## UCC21750 Schematic Review:

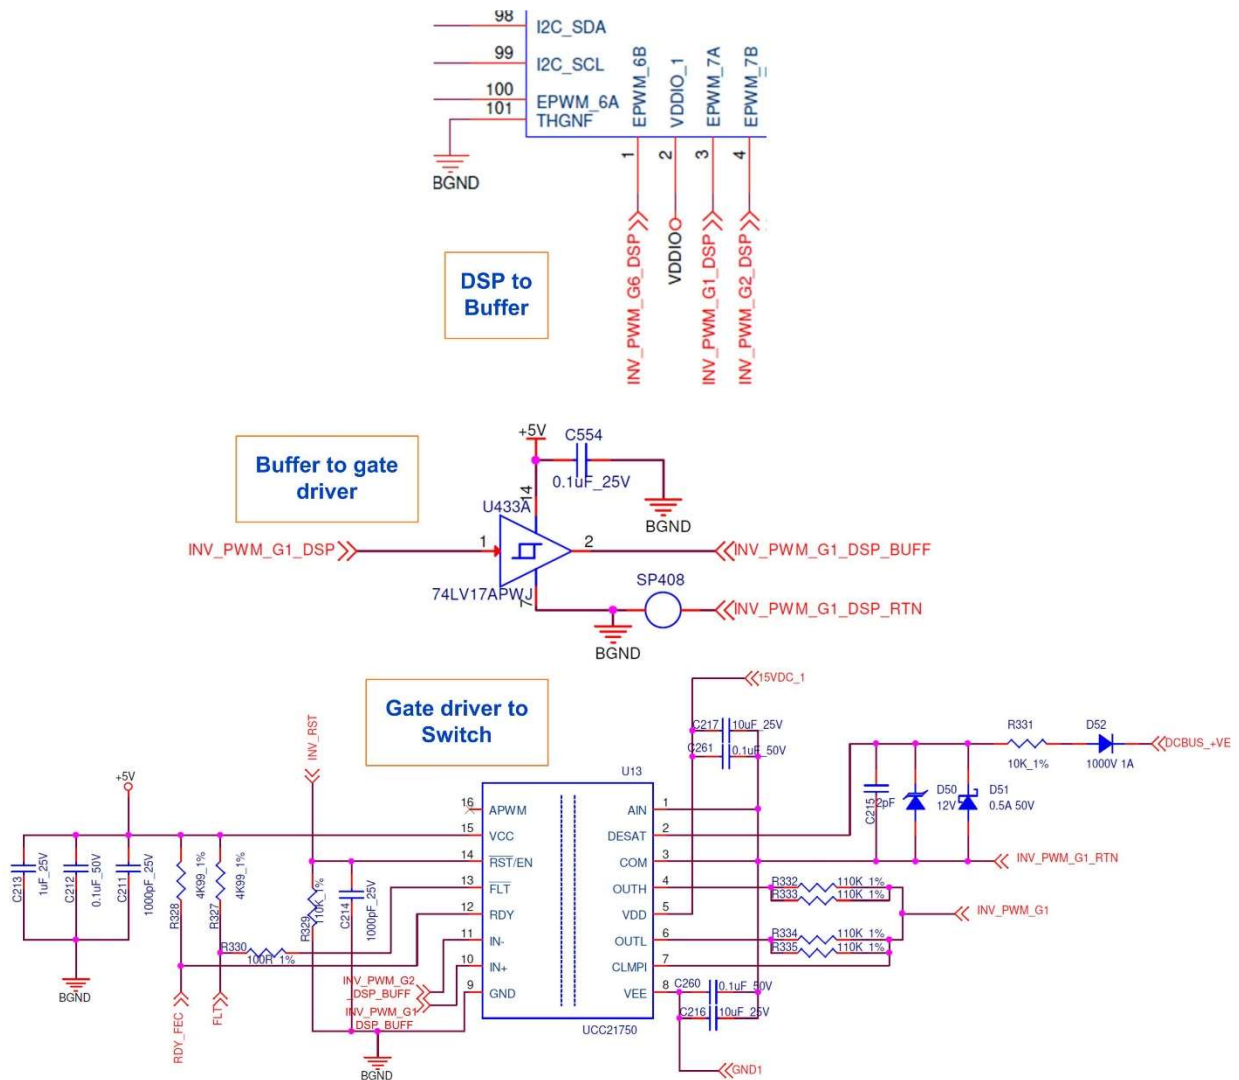
1. Consider adding ESD diode at AIN for OV protection (optional)
2. Increase the DESAT pin bypass capacitor (C215) to at least 220pF (make sure this and all bypass caps are close to device pins)
3. The resistances on the OUTL/OUTH pins are very large, this will cause increased switching loss and decreased peak sink/source current. Unless you are trying to slow down the switching speed of the FET these resistances don't need to be so large.
4. Make sure that the trace between the CLMPI pin and the gate is short
5. Consider an input RC filter at the IN+/IN- pins (optional)
6. Like FLT pin, RDY pin should have 5.1k pull up

7. R329 should be in series with C214 to create input filter, not in parallel
